Amendments to the Drawings

Attorney Docket No. 127976-1000

App. No.: 10/664,737
Reply to Office Action of 12/07/04
Annotated Sheet Showing Changes

FIGURE 11

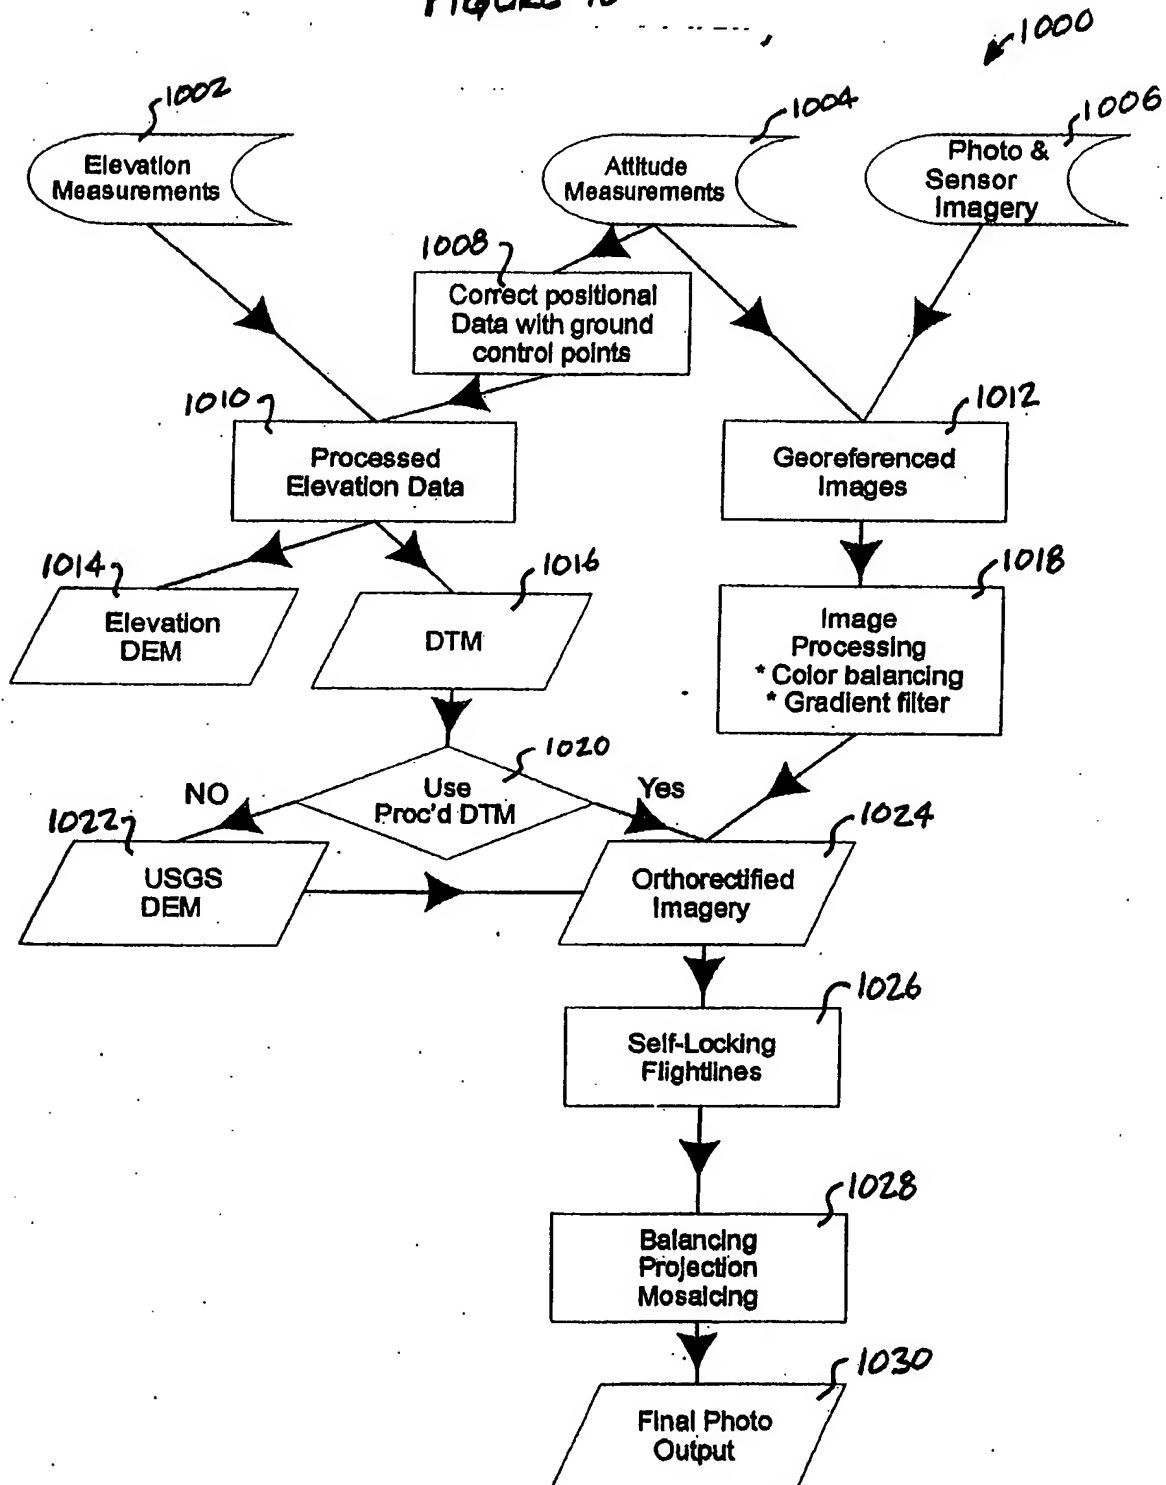
The sheet that includes Figures 11, 12, and 13 now replaces the original sheet that included Figures 11 and 12, and that portion of the sheet that included Figure 13. In Figures 11, 12, and 13 the lines identifying certain representational components have been repositioned for reasons of clarity. In Figures 11, 12, and 13, the boxes have been repositioned for reasons of clarity and stylistic preference. Additionally, Applicant has deleted some of the words in Figures 11, 12, and 13 without prejudice and for reasons of clarity. No new matter has been added to Figures 11, 12 and 13.

FIGURE 14

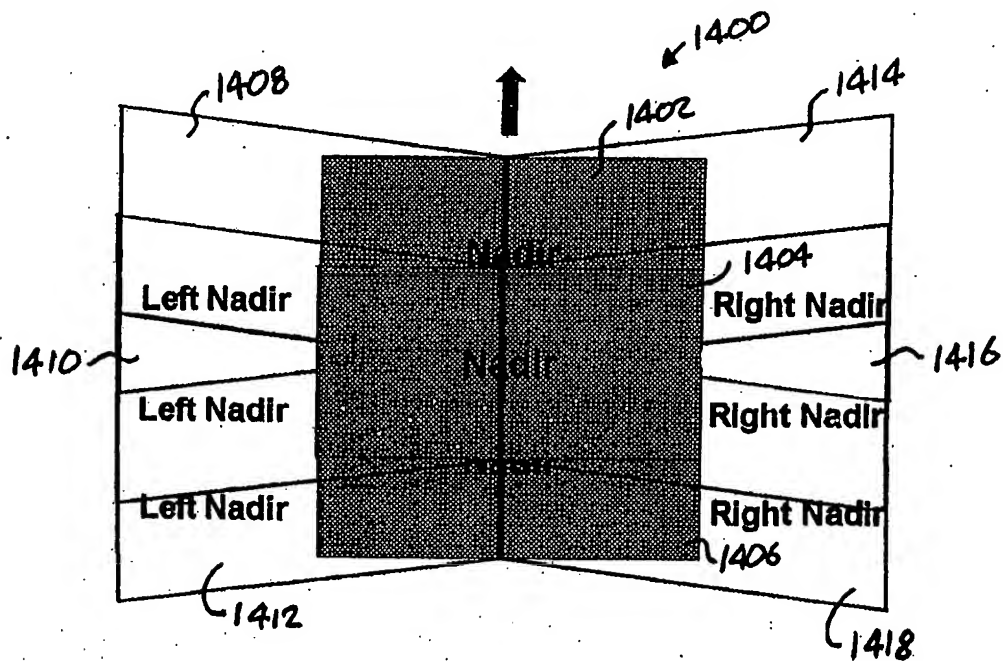
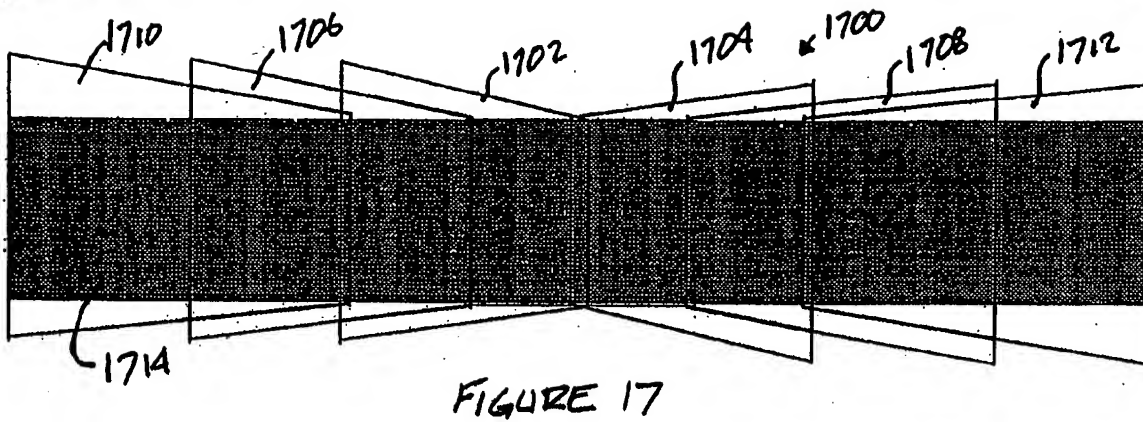
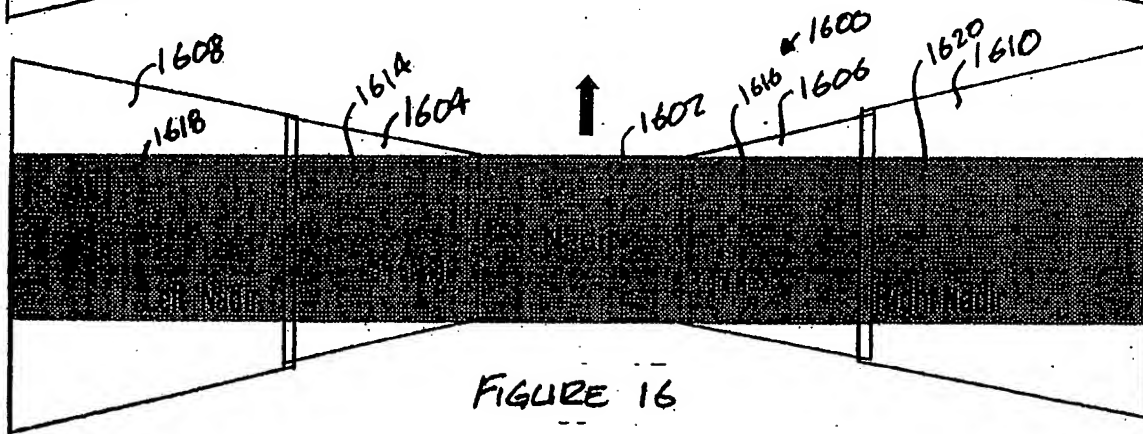
The sheet that includes Figures 14, and 15 now replaces the original sheet that included the portion of the sheet that included Figure 14 and the portion of the sheet that included Figure 15. In Figures 14 and 15 the lines identifying certain representational components have been repositioned for reasons of clarity. In Figures 14 and 15, the shape of the boxes have been changed and repositioned for reasons of clarity and stylistic preference. Additionally, Applicant has deleted some of the words in Figures 14 and 15 without prejudice and for reasons of clarity. No new matter has been added to Figures 14 and 15.

FIGURE 18

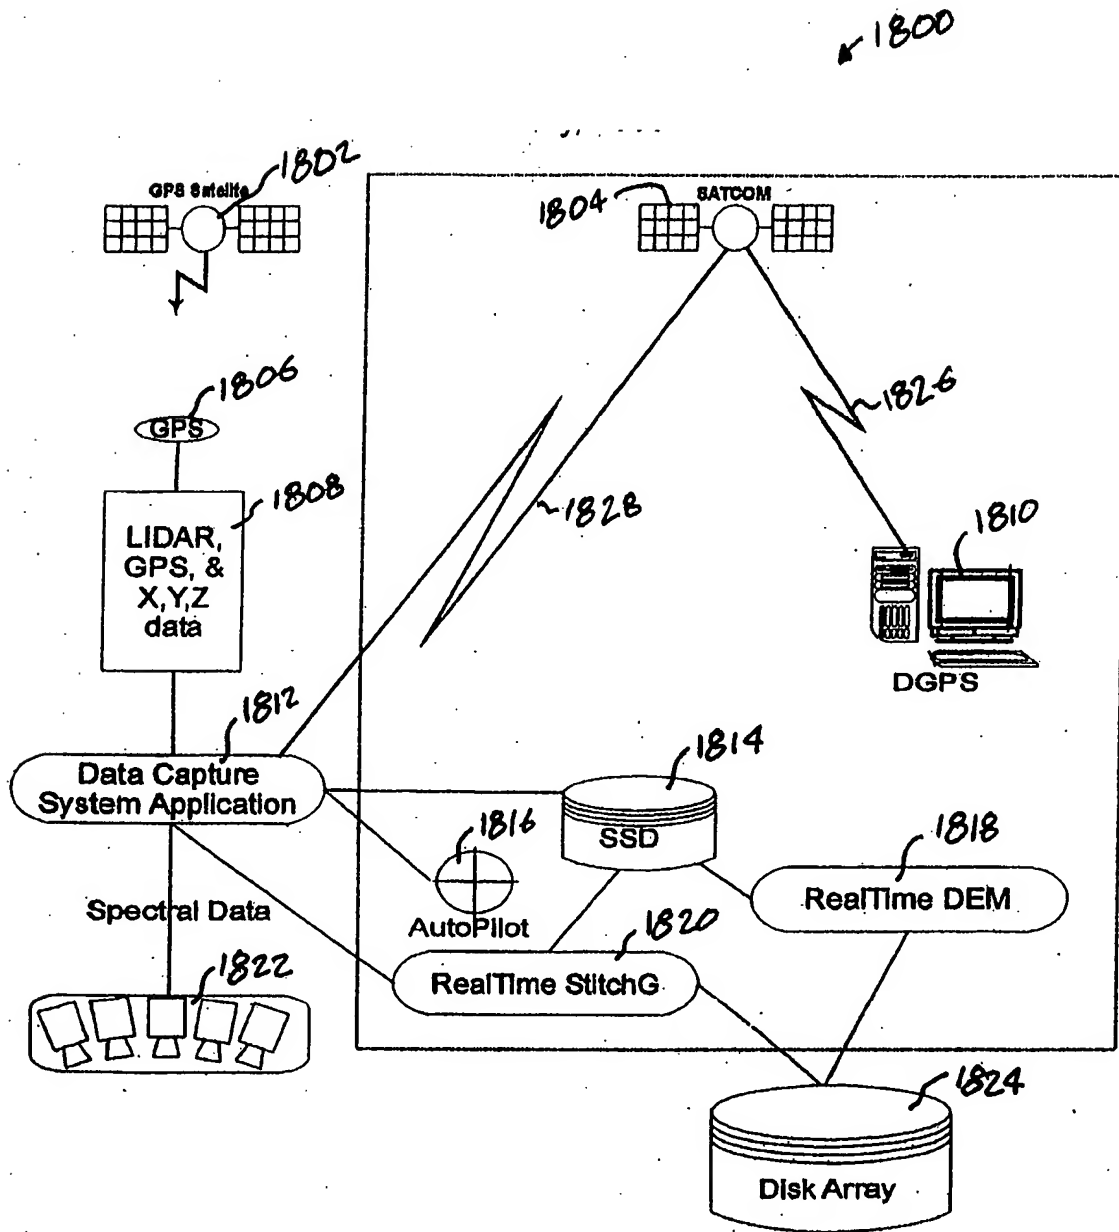
The sheet that includes Figure 18 now replaces the original sheet that included Figure 18. In Figure 18, the lines connecting and identifying certain representational components have been repositioned for reasons of clarity. In Figure 18, the shape of the boxes have been changed and repositioned for reasons of clarity and stylistic preference. Additionally, Applicant has deleted some of the words in Figure 18, without prejudice and for reasons of clarity. No new matter has been added to Figure 18.
